Meeting Date: Tuesday 4 November 2014
Location: Committee Room 2, Level 5, Civic Centre, 1 Devlin Street, Ryde
Time: 5.00pm

NOTICE OF BUSINESS

Item		Page
1	CONFIRMATION OF MINUTES - Meeting held on 7 October 2014	1
2	46-48 GLADSTONE AVENUE, RYDE. LOTS F and G DP 32873. Local Development Application for demolition of existing structures and construction of a 3 storey residential flat building containing 12 apartments and car parking for 16 vehicles. LDA2013/0173. <i>INTERVIEW 5.00PM</i>	6
3	492 BLAXLAND ROAD, DENISTONE. Development Application for a multi dwelling housing development comprising four (4) dwellings pursuant to the provisions of State Environmental Planning Policy (Affordable Rental Housing) 2009. LDA2014/0220.	106

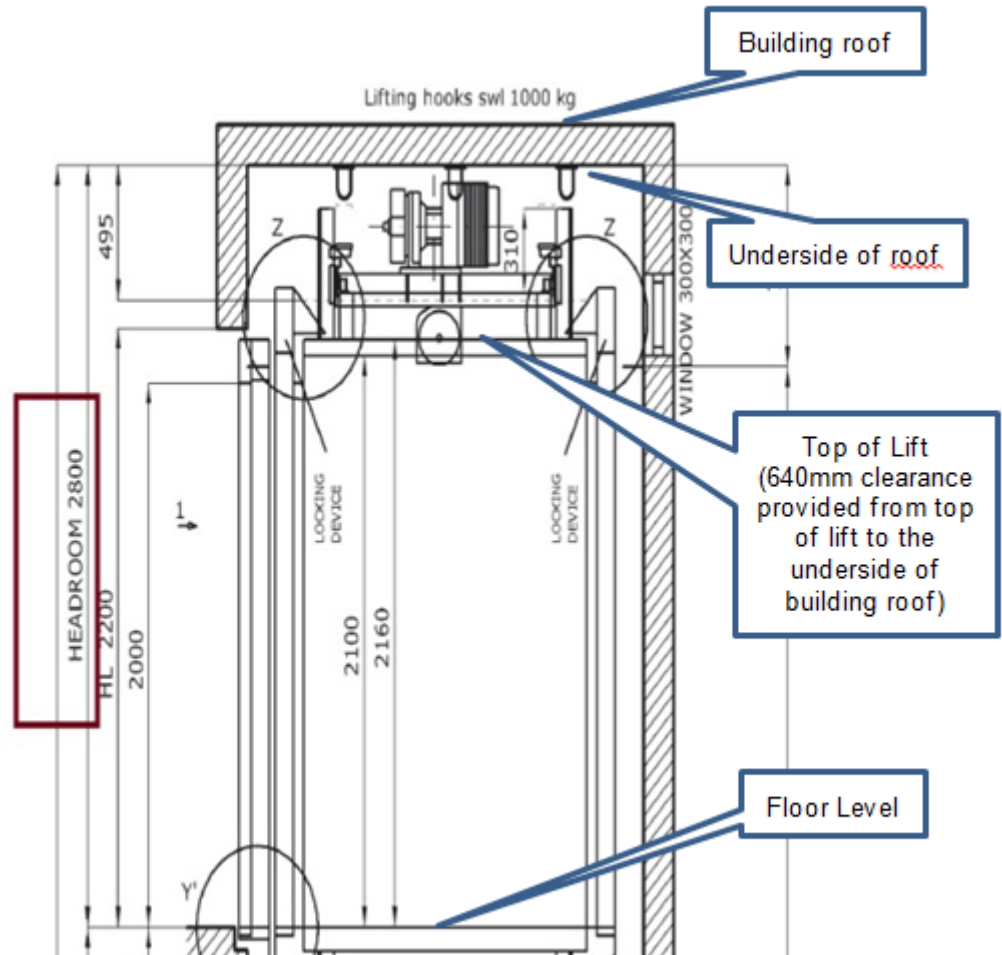
- c) **Height non-compliance:** *We do not support any variation to the building height. Height compliance cannot be achieved for the following reasons:*
- i. *The lift overrun has not been shown on the plans and if the overrun is accounted for, it will result in height non-compliance;*
 - ii. *The proposed floor to floor heights are minimal and would not be sufficient to support the slab thickness, services and fittings within the roof.*

No variation to the 9.5m building height is proposed. The proposal demonstrates full compliance with the maximum building height which is discussed in detail later in this report. With respect to the lift clearance and floor to ceiling height the following comment is provided:

FLOOR PLAN SHOWING WINDOWS RELATIVE TO ADJOINING PROPERTY

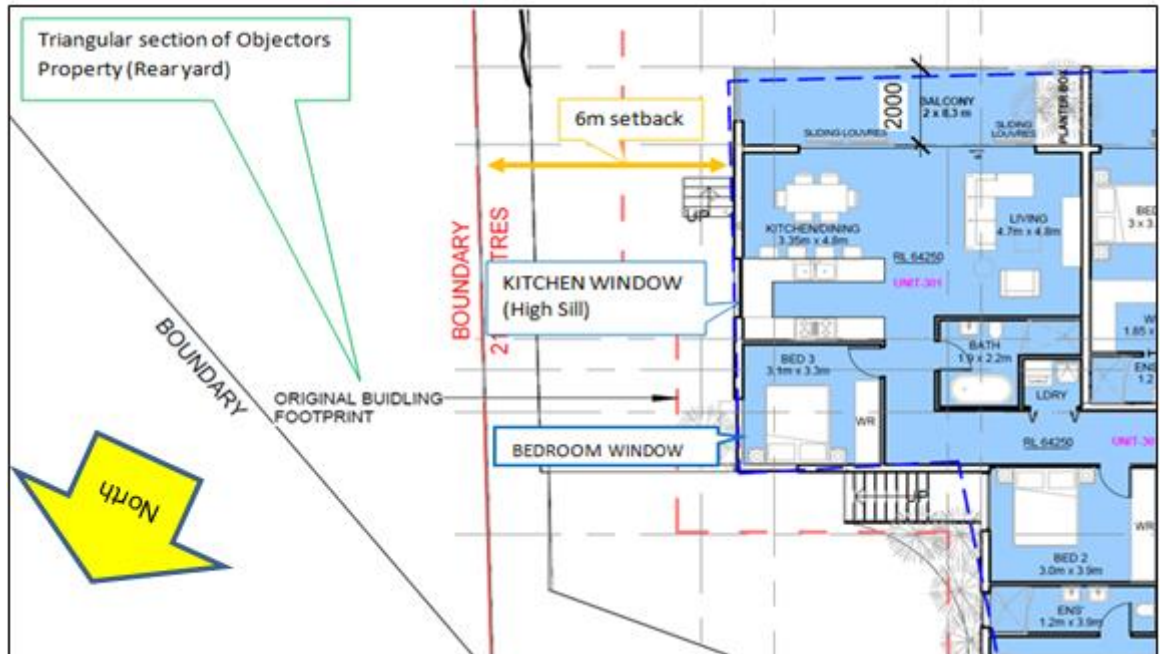
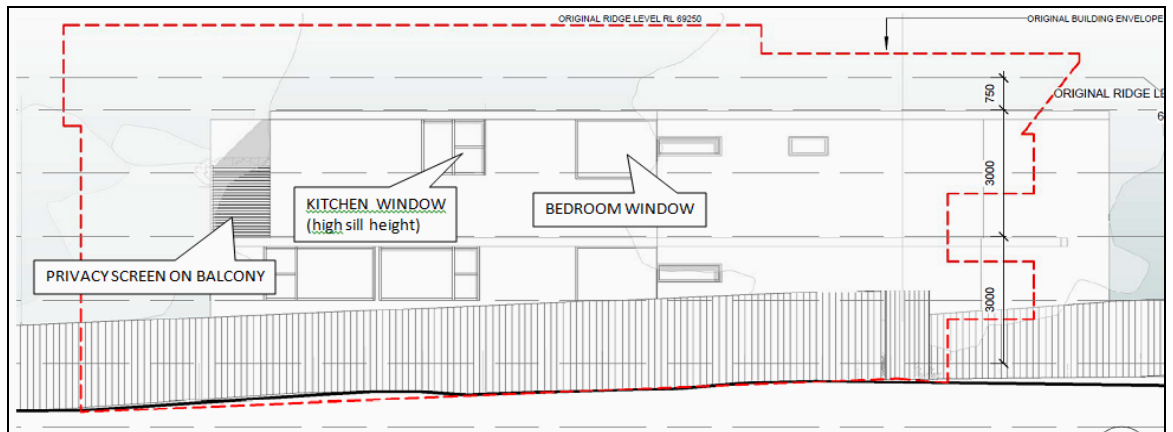
the windows on the northern side of the development and the proposed screening or lack thereof for the balconies overlooking our property. If the development is permitted to proceed then it must provide solid infill panel balustrades and permanent shutter screening on all balconies.

With respect to the windows on the north elevation, there are 2 windows on Level 2 units. One of the windows is off a bedroom which would mostly be occupied during night and would not result in any significant privacy problems. The other is a kitchen window with sill height of 1.7m. Overlooking impacts will not result from this window.

The amended proposal has deleted all balconies facing northern side boundary in order to address privacy issues. Direct overlooking is not possible to an extent that would result in privacy concerns. Given that the building separation requirement is complied with where the windows are located, and that there are no balconies or living room windows which would have direct line of view from the windows to living room of the dwelling on No 39 Princes Street, it is deemed that privacy matters have satisfactorily been addressed on the north elevation. Given the above, privacy screens on the windows are not necessary.

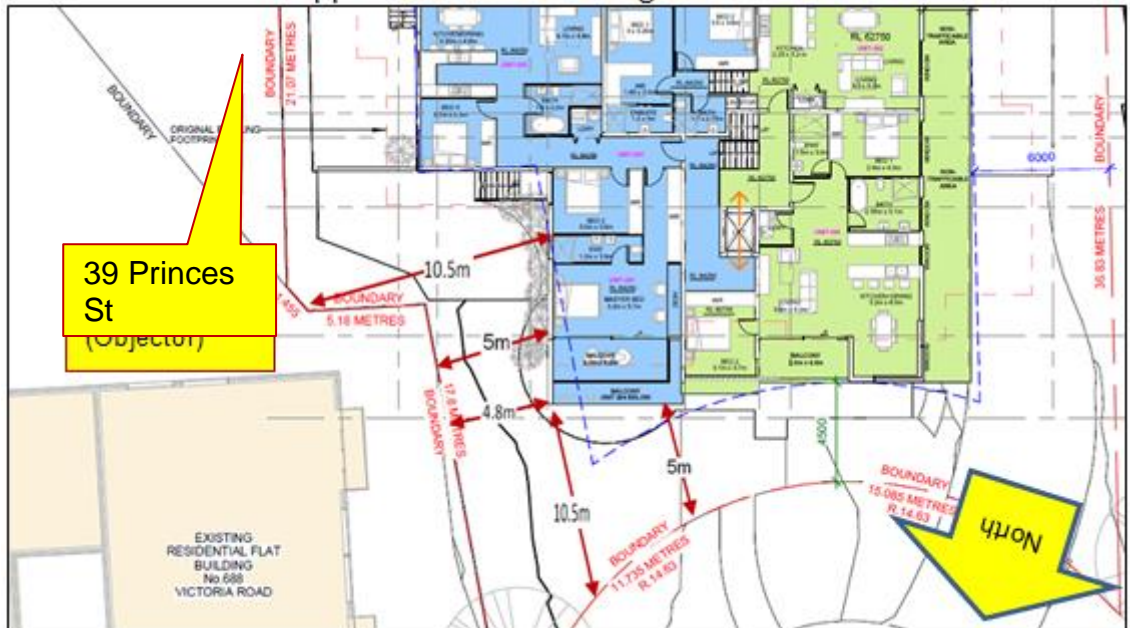
- p) ***Pergola too close to the boundary:*** *Such a structure would also provide access to backyard of 39 Princes Street for any person wishing to climb the pergola. Any pergola erected should have clearance from our boundary to reduce this risk to our security and noise.*

The amended plans now show that the pergola over the ground level communal open space will be set back 1.2m from the side boundary and 2.4m – 4m from the ***Casuarina glauca*** tree.

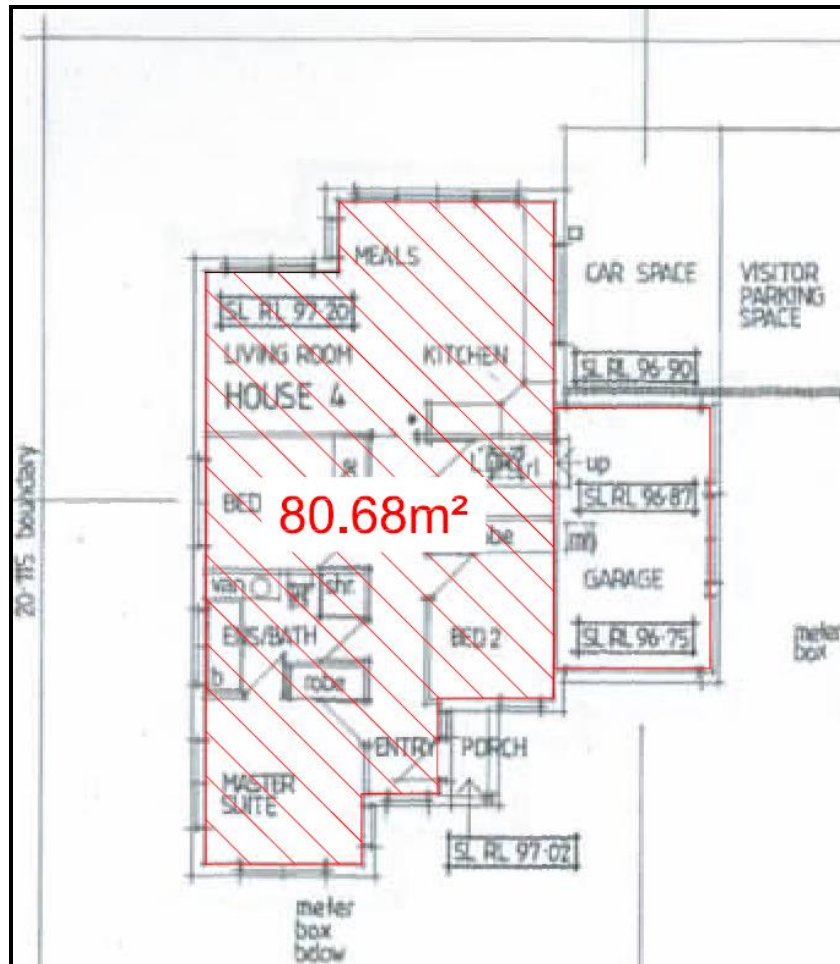
The Standard Instrument defines 'gross floor area', and using the applicable definition, with the benefit of CAD (Computer Aided Design), when applying the above definition to Dwelling 4 the calculated GFA of this dwelling to be 80.68m². A copy of the CAD calculation diagram is indicated below in Figure 6.

Even when allowing for some small deviations associated with plan scanning, the Dwelling 4 falls substantially short of the minimum dwelling size requirements, and as such is not supported due to the aforementioned internal amenity reasons.

Figure 10: Landscape Plan extract showing the landscaping strips along the side boundaries to be only 800mm wide. The Ryde DCP 2014 requires such landscape strips to be 1,200mm wide to enable landscape planting that will assist in the provision of visual privacy to adjoining development.

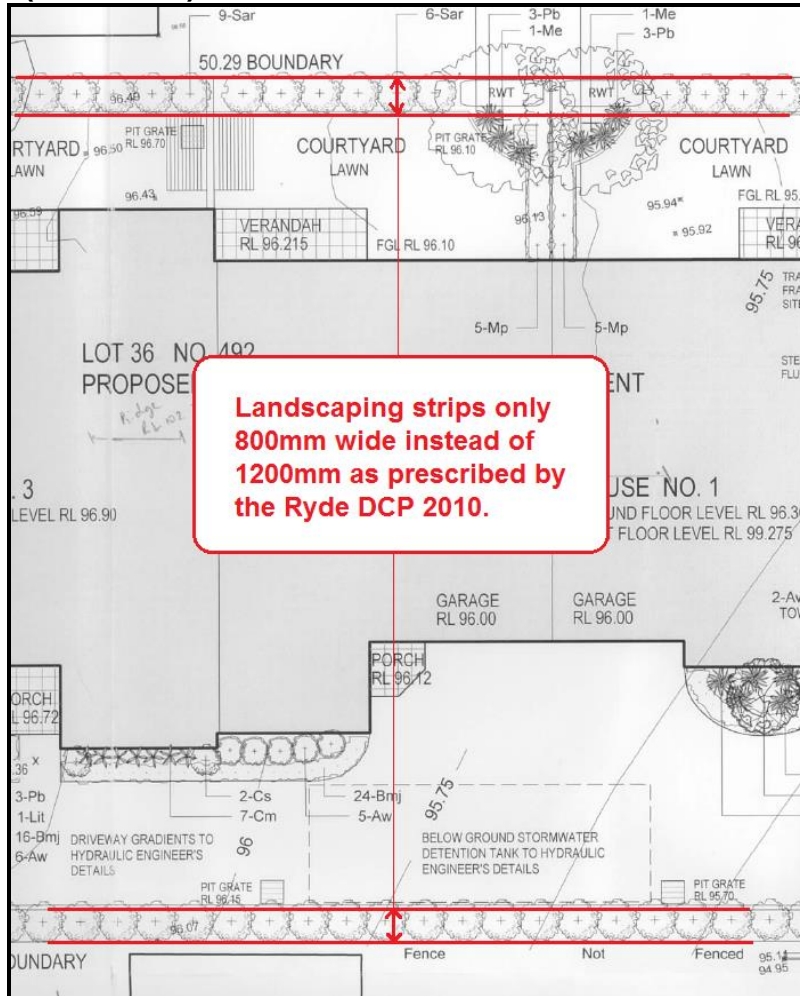
This 400mm non-compliance with the above planning control is not considered justifiable because the proposed privacy strip is inadequately sized to provide sufficient planting to assist in the privacy of occupants within the development and to the adjoining property. Furthermore the inability to provide for a suitable landscape strip is considered to be further evidence the proposal represents an overdevelopment of the site, particularly when taking into consideration the proposed development's non-compliance with other planning controls contained within the Ryde DCP 2014 such as minimum setbacks and private open space area.

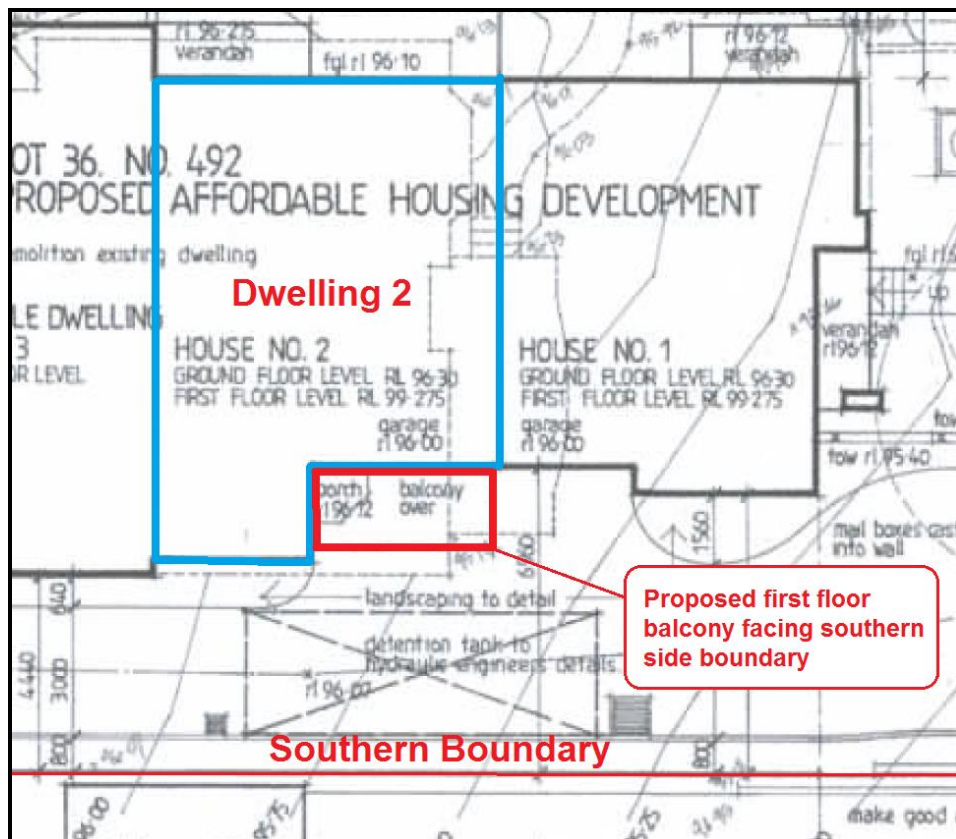
The proposed development includes a balcony on the upper level of Dwelling 2 which faces the south-eastern side boundary toward the adjoining property at No. 490 Blaxland Road.

This balcony is located on the first floor of the dwelling and as such will facilitate overlooking to the neighbouring property. On this basis, the proposed balcony on Dwelling 2 is not supported.
